CENTER FOR NUCLEAR WASTE REGULATORY ANALYSES

NONCONFORMANCE REPORT

Project No. 20-01402-571

NCR No. 2001-07

FIND NO.	QTY REQ.	SIZE	CODE IDENT. NO.	PART OR IDENTIFYING NO.	NOMENCLATURE OR DESCRIPTION	
					PARTS LIST	
					SOUTHWEST RESEARCH INSTITUTE	
					1T PLAN C(T) SPECIMEN: W/4 THICK	
					DRAWING NUMBER 06-2795-1 REV I	
					SCALE 1=1 SHEET

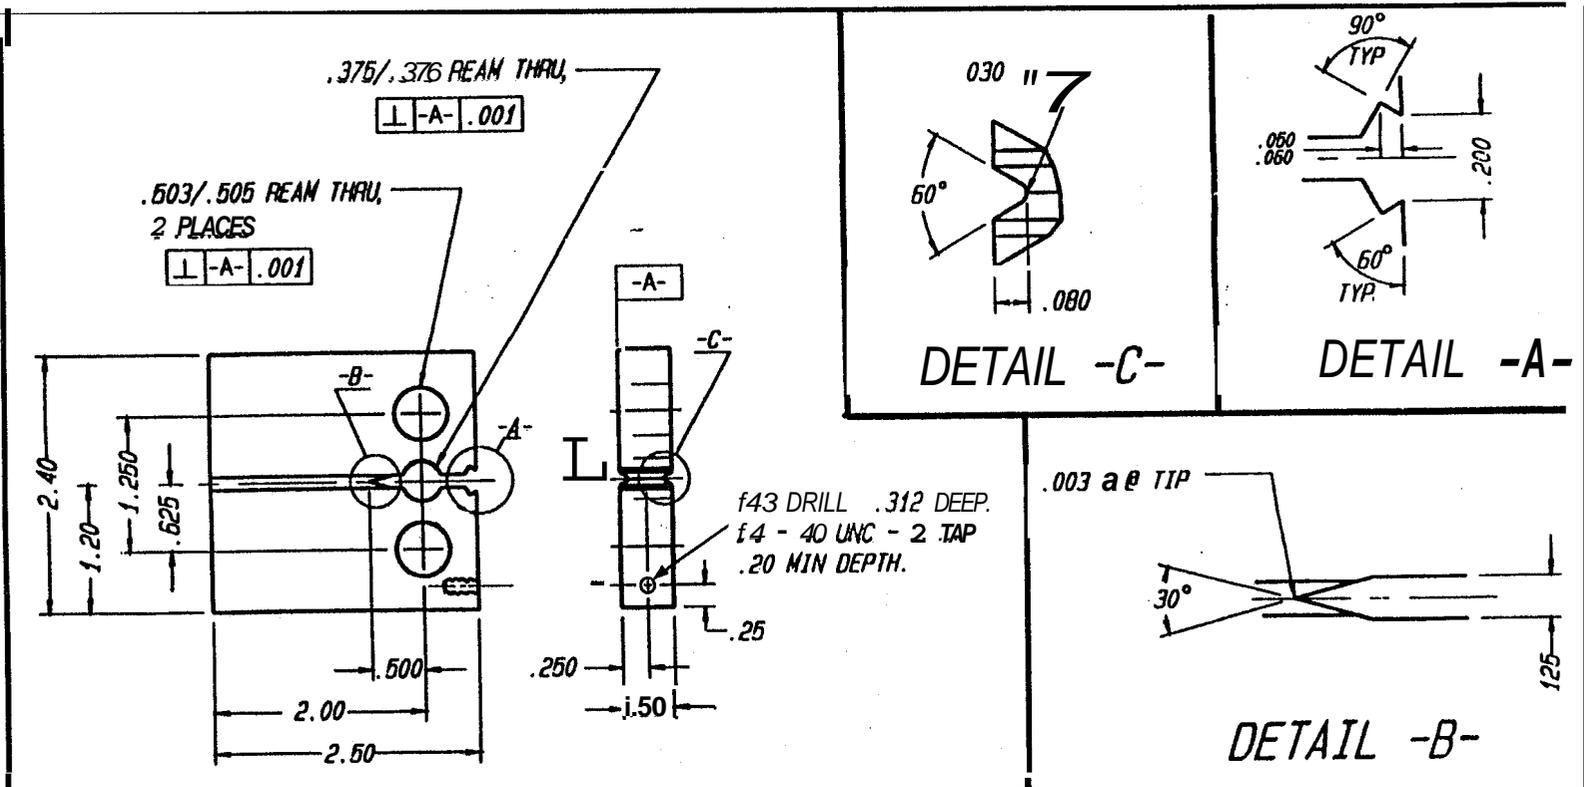
Purchase order 183724S from Metal Samples Inc. received 3/23/01 was found to have 8 of 8 compact tension specimens out of tolerance per CNWRA drawing 06-2795-1. The dimensional tolerance was specified as ± 0.001 inches. Specimens found to be out of tolerance had dimensional measurements ± 0.003 inches to the specifications provided in CNWRA drawing 06-2795-1. Detail C of CNWRA drawing 06-2795-1 specifies an included angle of 60° with a dimensional tolerance of $\pm 0^\circ 30'$. Inspection of the specimens revealed that 6 of the 8 specimens were out of tolerance with respect to the included angle specification.

The specified dimensional tolerance for CNWRA drawing 06-2795-1 is ± 0.001 inches for dimensions under 6 inches with dimensional specifications to 3 decimal places. This tolerance is unnecessarily tight. Dimensional specification tolerances for compact tension specimens provided in American Society for Testing and Materials (ASTM) Designation E399-90, Standard Test Method for Plane-Strain Fracture Toughness Testing are ± 0.005 inches.

The dimensional specification tolerances in CNWRA drawing 06-2795-1 will be revised and the drawing will be updated to reference the 0.005" tolerance. The tolerances of the included angles have been revised to $\pm 1^\circ$.

Drawing 06-2795-1 has been revised and identifies revised tolerances.

BASIC DIMENSIONS	DECIMALS		FRAC	CONTRACT	
	2 PLACE	3 PLACE		DWN	
UNDERS	± .01	± .005	± 1/32	2-7-1995	A.NAGY
6-24 INCL	± .03	± .010	± 1/16		
OVER 24	± .06	± .01	± 1/8		
ANGLES	± 1°		± 1°	05-03-01	D.DUNN
